**Re: Site Plan – Upper Slate School
5100 Ridge Road
North Haven, Connecticut
SLR #141.16156.00003**

SLR International Corporation (SLR) is in receipt of your memorandum dated April 14, 2021, regarding the above-referenced project. We offer the following responses to the comments contained therein:

141.16156.00003.m1421.ltr

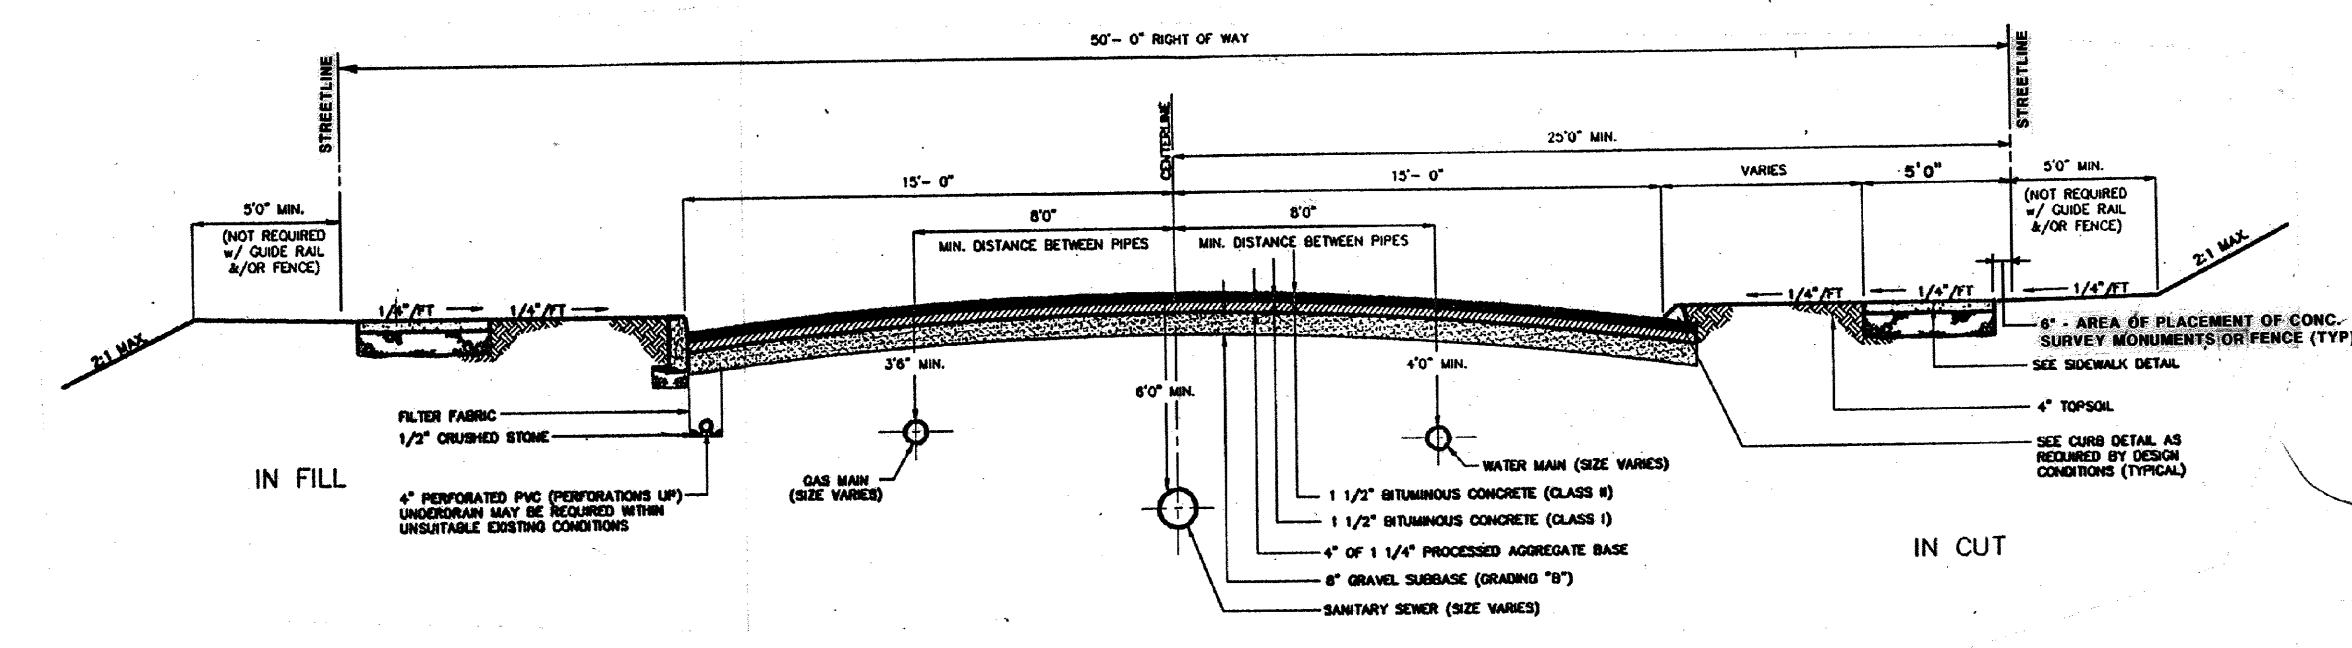
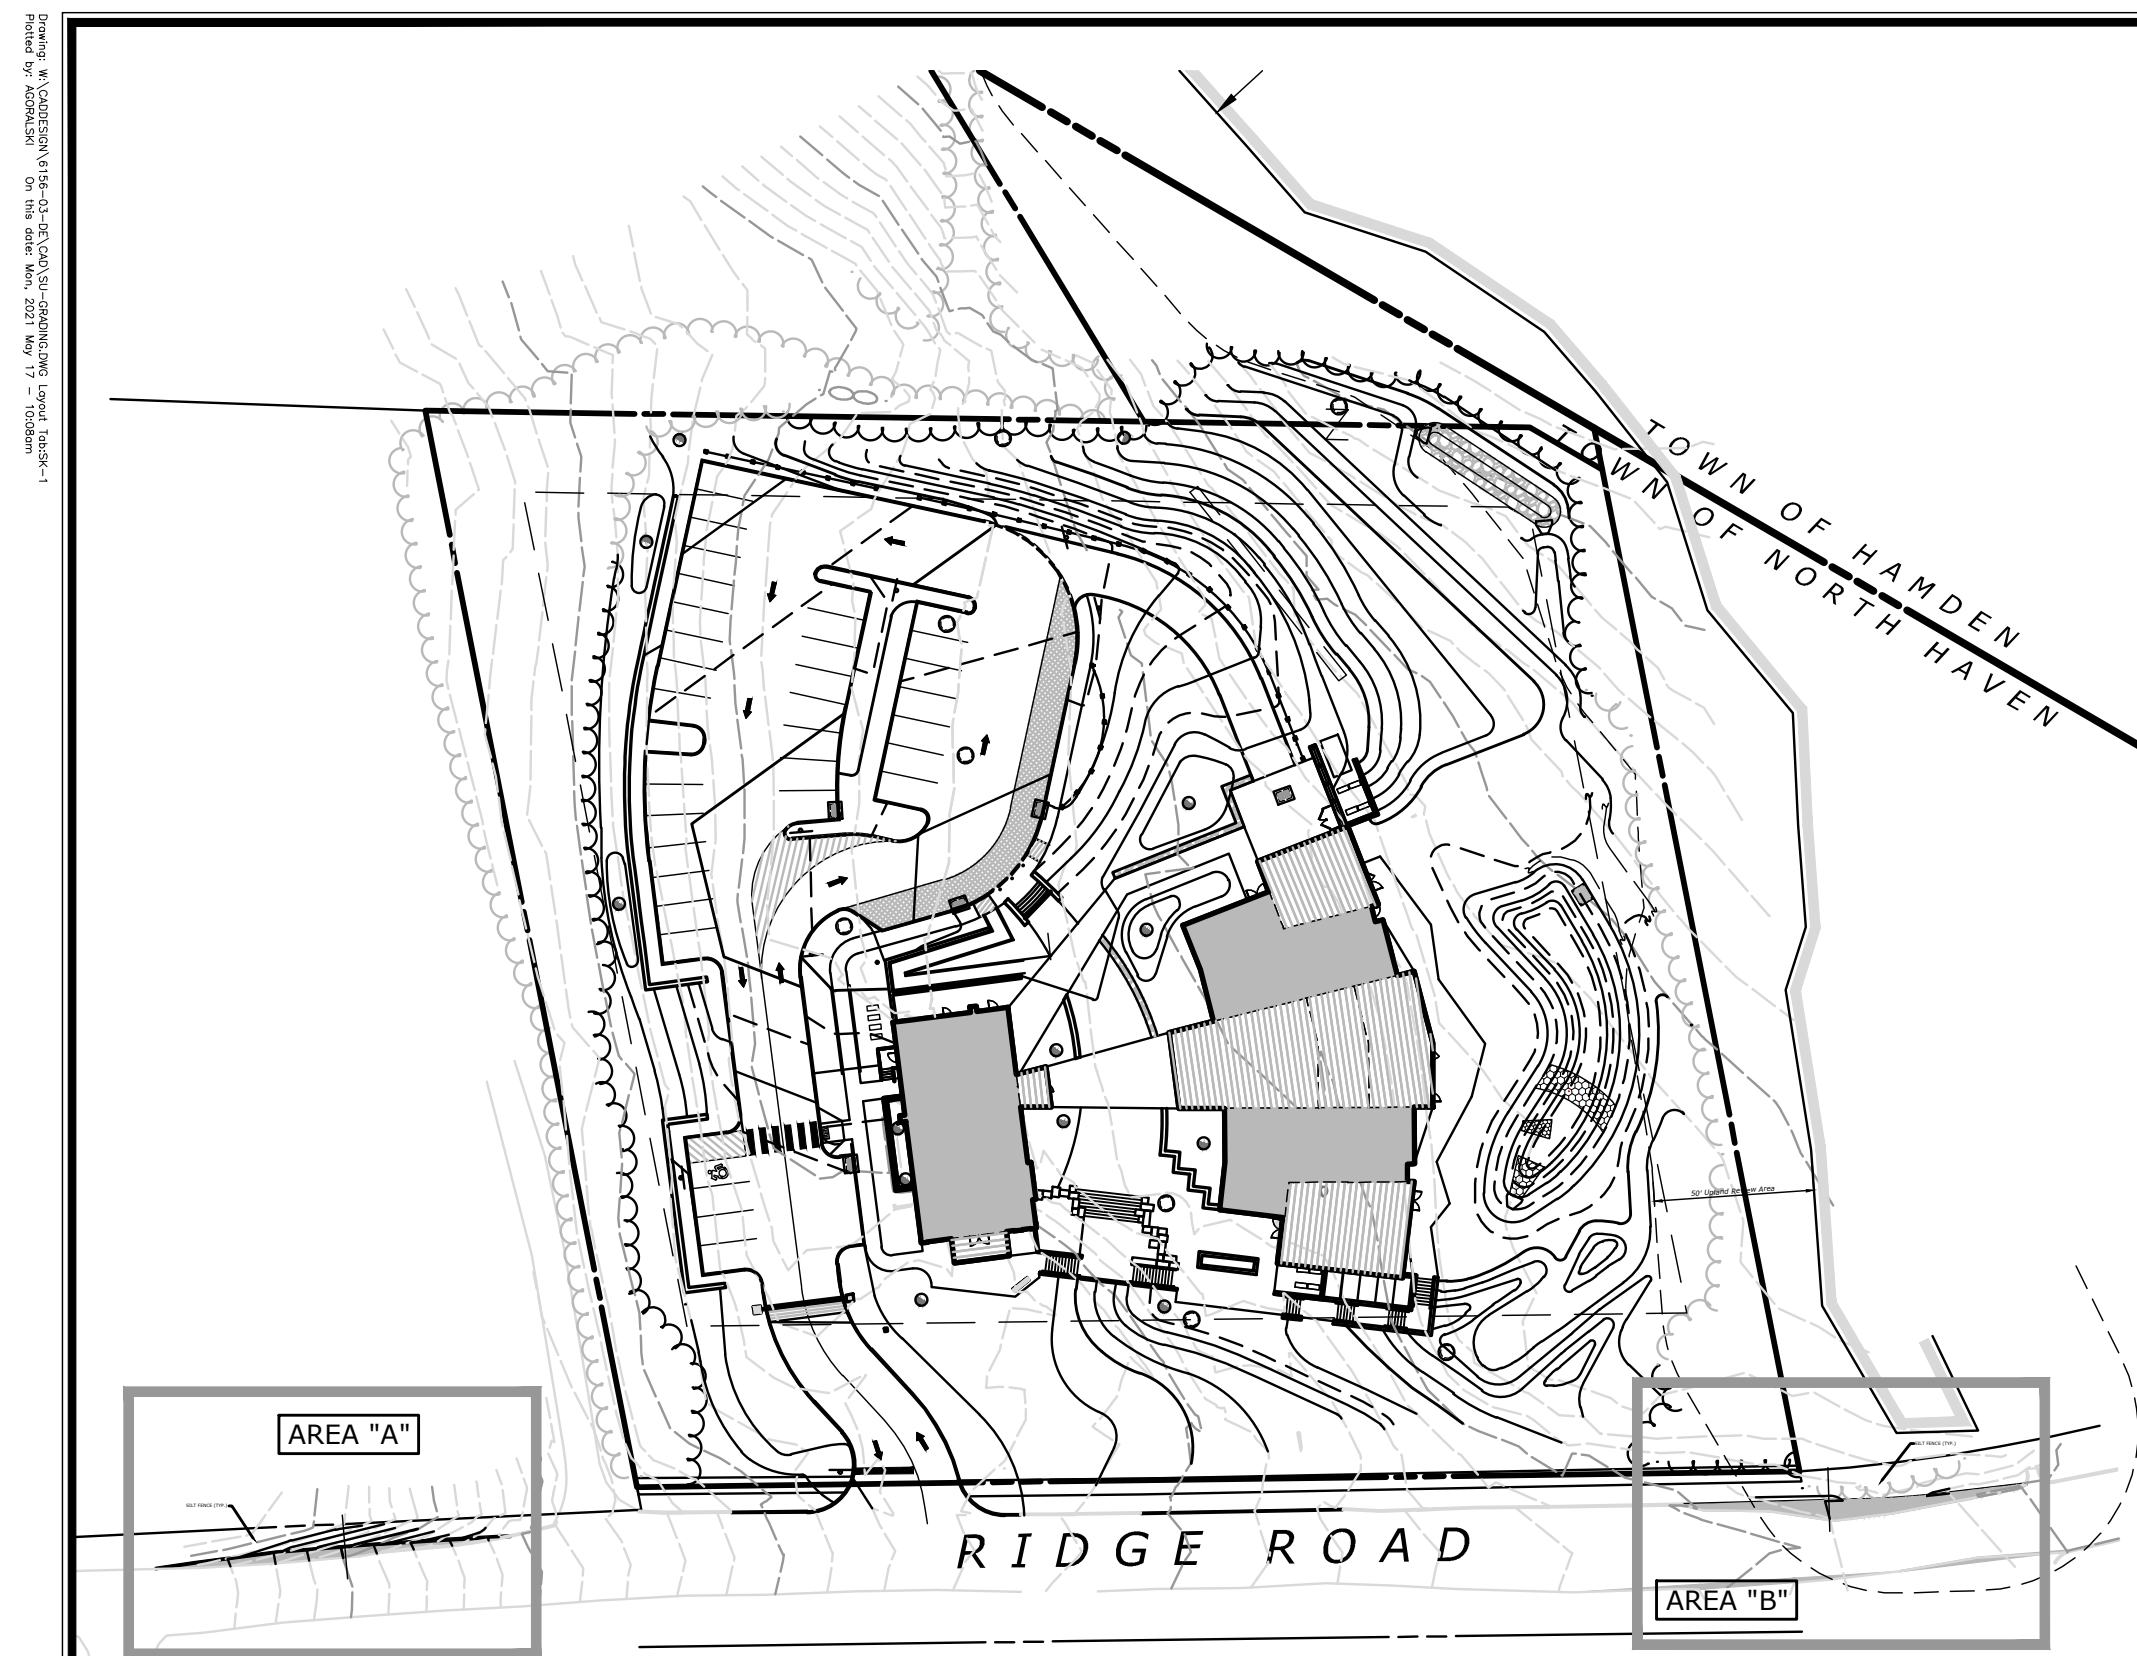
- R1. Noted.**
- C2. More detail is needed on the proposed road widening including cross sections, detailed grading plans, a detailed layout plan (with dimensions), and details on the proposed pavement section, and bituminous curb. A line of silt fence should be provided downgradient of the road widening section. Coordinate relocation of the existing utility pole within the southerly road widening area.

- R2. Please see enclosed sheet SK-1.**
- C3. MH 17 should be replaced with a Gross Particle Separator in order to screen stormwater prior to entering the underground detention system.

LA-1

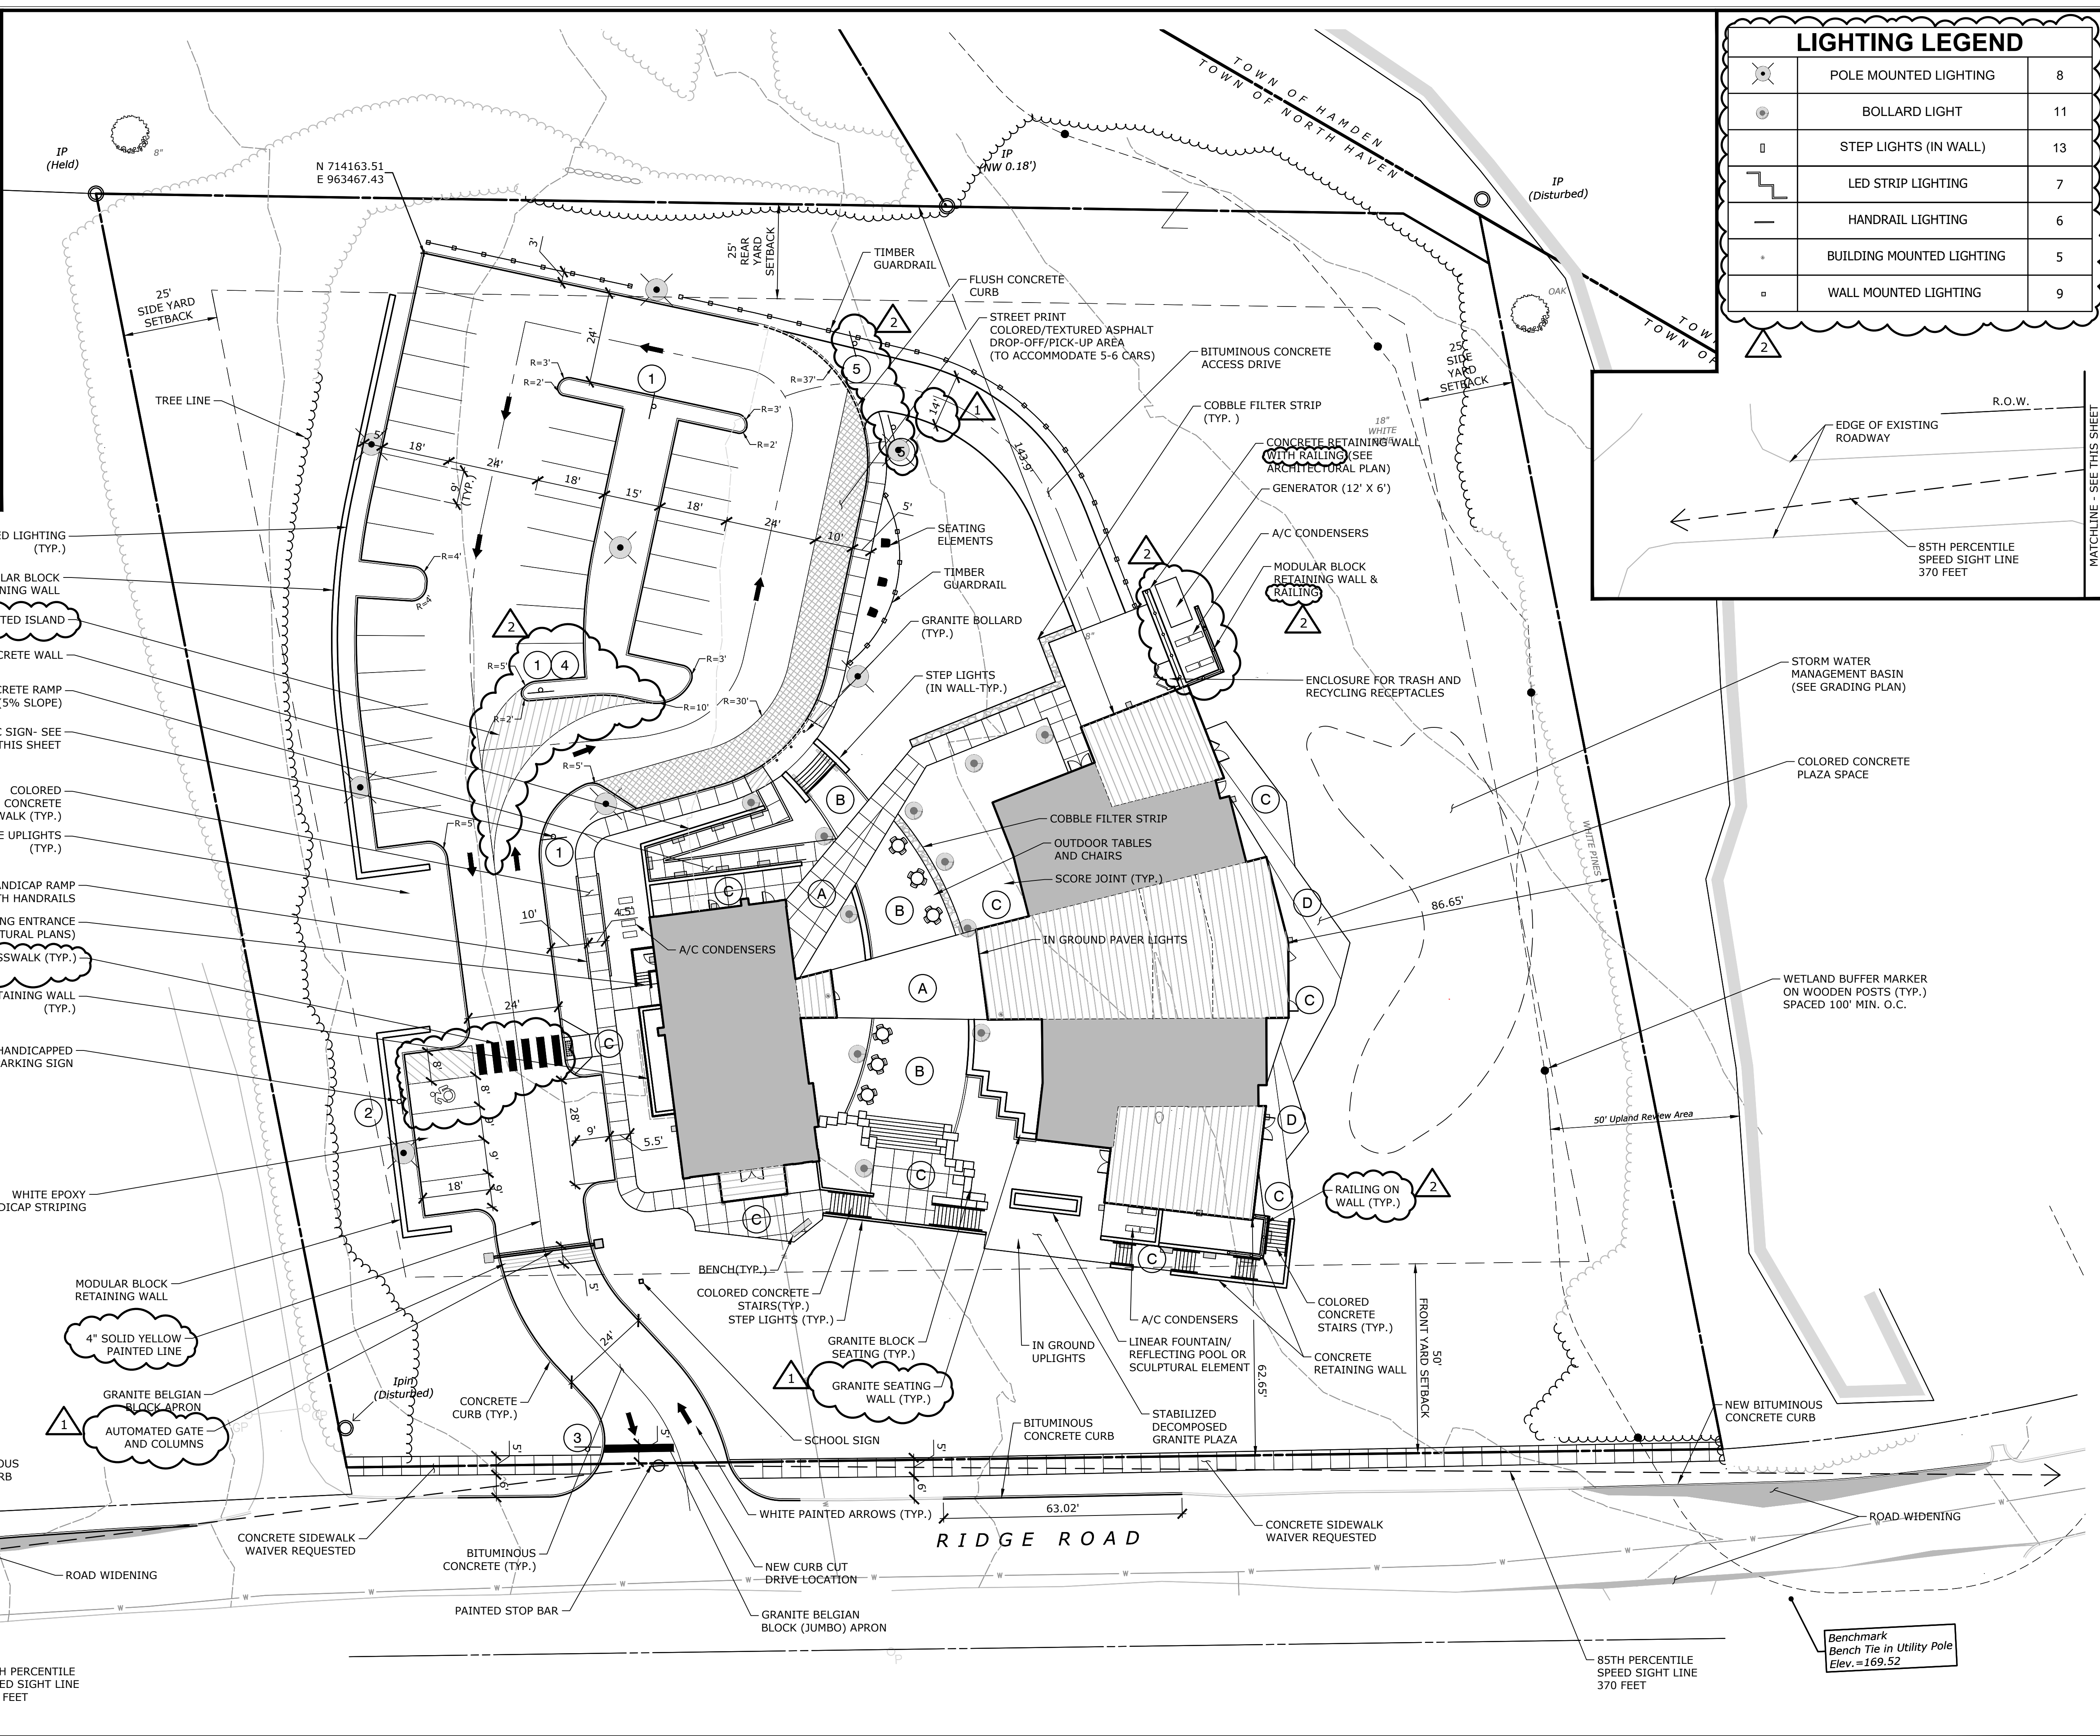
- C5. Improve signage, and/or provide additional channeling islands in order to prevent vehicles entering the main parking lot from going the wrong way.

- C6. Provide an additional sidewalk section, handicap ramp, signage, and cross walk just west of the handicap parking spot in order to allow handicap users to safely cross the entry driveway.

- R7. Two "Service Vehicle Only" signs have been added at the entrance to the utility access drive.**
- C8. A fence or other means of protection should be provided at the top of retaining walls exceeding three feet in height.

- R5. A "Do Not Enter" sign has been added to the "One Way" sign post and its location has been shifted to the southeast to align with the driver's viewshed upon entering the driveway. Additionally, a painted island has been added and a single 4" yellow line is proposed along the drive entrance.**

- R6. See revised Layout sheet LA-1 (enclosed).**
- C7. Provide signage, gate, and/or pavement markings to restrict access to the utility access driveway.

- R8. Railings have been added to the retaining walls on the northwest and northeast corners of the proposed building. See sheet LA-1 (enclosed). Retaining wall guards have not been added to the walls along the southern property line as dense vegetation limits pedestrian access to them. This complies with the Amendments to the *State Building Code* section R312.1: "Retaining walls with a difference in finished grade from top of the wall to the bottom of the wall that is greater than 4 feet shall be provided with guards complying with Section R312 when there is a walking surface, parking lot, or driveway on the high side located closer than 2 feet to the retaining wall. For the purposes of this section, grass, planting beds or landscaped areas shall not be considered a walking surface."**
